ADDENDUM NO.1

SULLIVAN MIDDLE SCHOOL ATHLETIC RESTROOM/CONCESSION BUILDING

ROCK HILL SCHOOLS
BID PACKAGE 1:
BID # 19-2024 SITE PREPARATION & UTILITY CONNECTIONS

February 25, 2020	VOLUME 1 OF 1	APN # 593120
-------------------	---------------	-----------------

- KEYNOTES**
 APPLIES TO THIS DRAWING REPRESENTED BY [n]
- ELECTRIC WATER HEATER LOCATED AS HIGH AS POSSIBLE ON GALVANIZED STEEL SUPPORT PLATFORM AND DRAIN PAN. ROUTE FULL SIZE DRAIN TO FLOOR DRAIN IN CHASE. PROVIDE HOLDRITE QUICKSTRAP EQUIPMENT PLATFORM OR EQUAL.

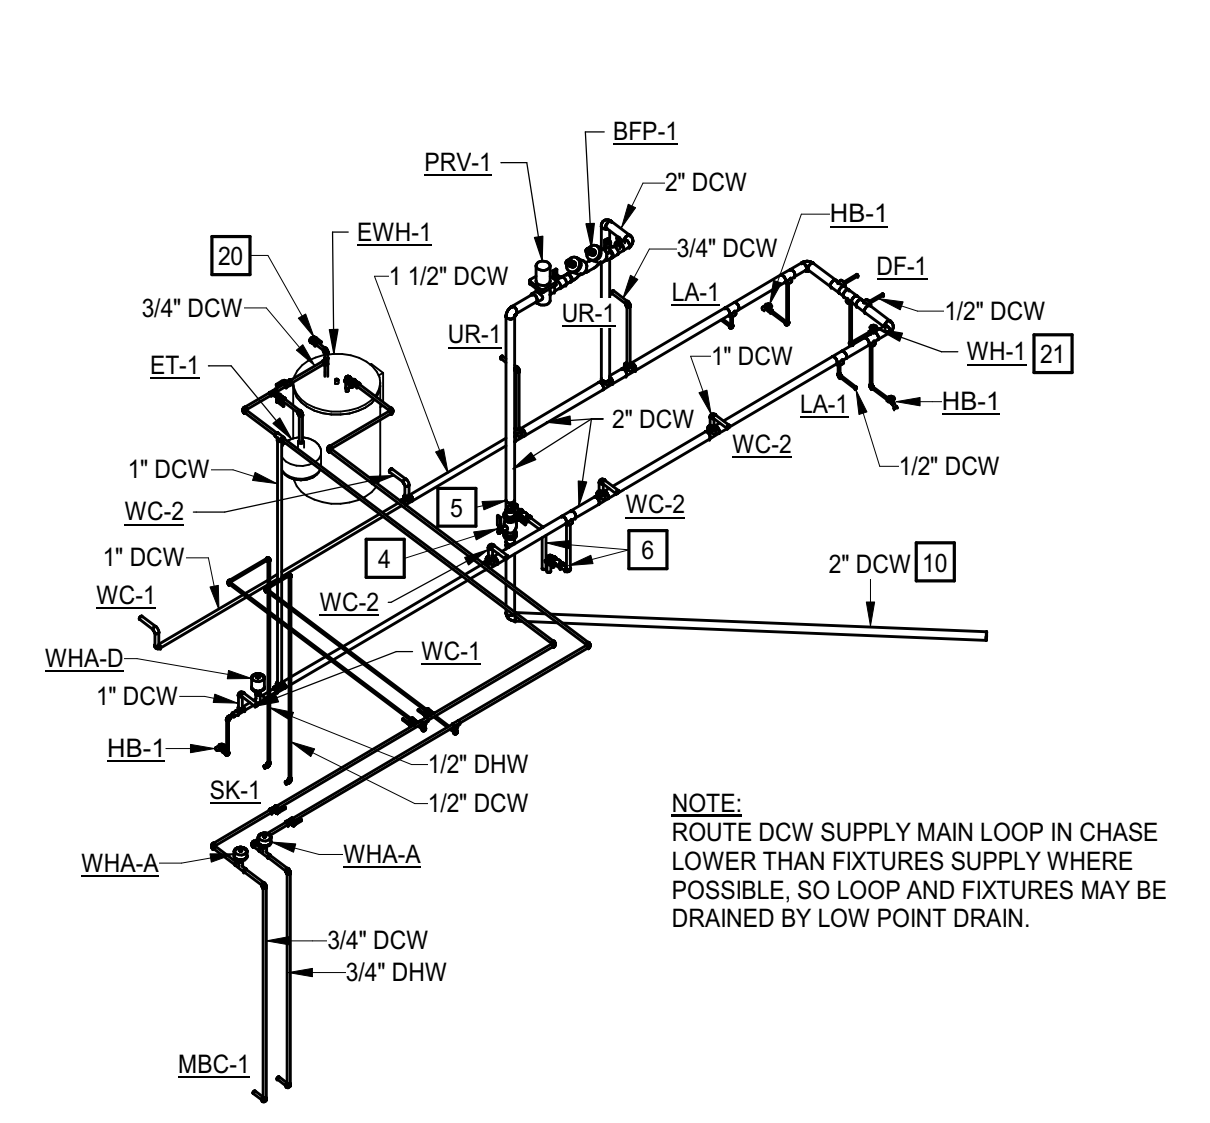
- 15) How will the FD-1 in the chase, as well as Women's C004, be vented? Which of the two trap primers or trap guards to be used on the floor drains?
- a. The new under-slab vent is shown on plans as ADD 01.
 - b. Trap Guards shall be installed along with deep seal p-traps on ALL floor drains and floor sinks per Plumbing drawing P2.0.1, Drain, and Cleanout Schedule.
- 16) Substitution Request: Machflow had drier in lieu of Xlerator.
- a. Approved Substitution
